URGENT FIELD SAFETY NOTICE

Tibial Components / Modular Joint Component Units of
Endo-Model – M Modular Knee Prosthesis System

Tibial Components of
Endo-Model SL Rotational and Hinge Knee Prosthesis System

2. Reason for Field Safety Corrective Action (FSCA)

Endo-Model SL

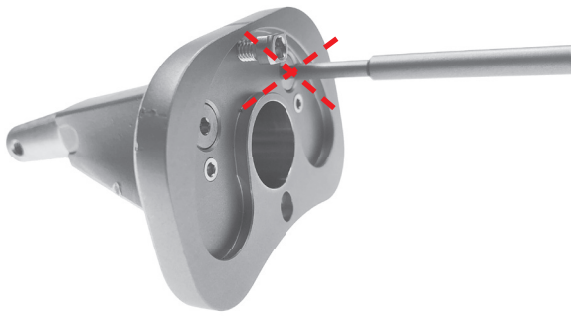
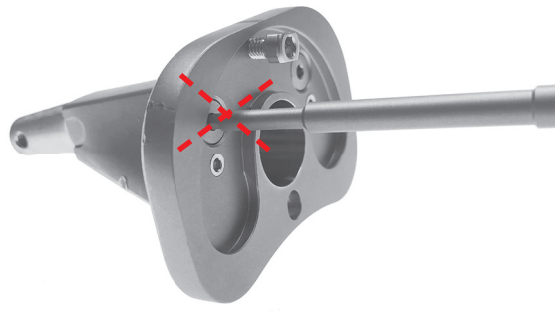
If a Tilastan proximal spacer is to be used and either one or both blind screws of the modular tibial component cannot be loosened, then the following modified surgical technique is to be performed.

= screw removal impossible?

<p>It has to be observed that a homogenous cement mantle between the Tilastan proximal spacer (full & half) and modular tibial component is ensured. The cement mantle should be 1-2 mm thick.</p>

Endo-Model – M

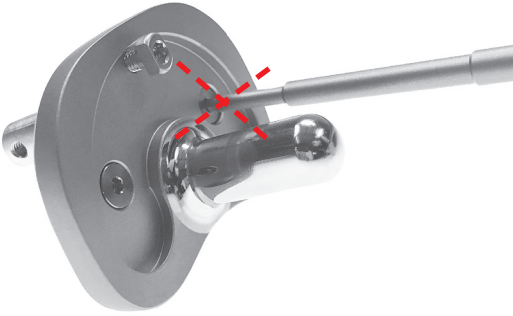
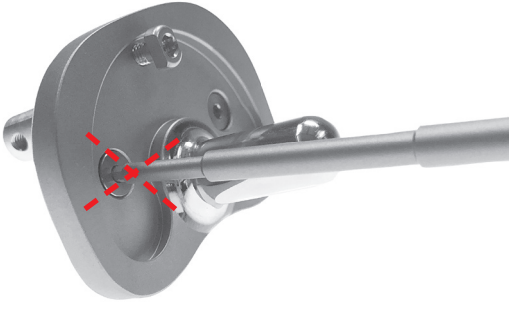
If a Tilastan proximal spacer is to be used and either one or both blind screws of the modular tibial component cannot be loosened, then the following modified surgical technique is to be performed.

= screw removal impossible?

<p style="color: green;">It has to be observed that a homogenous cement mantle between the Tilastan proximal spacer (full & half) and modular tibial component is ensured. The cement mantle should be 1-2 mm thick.</p>
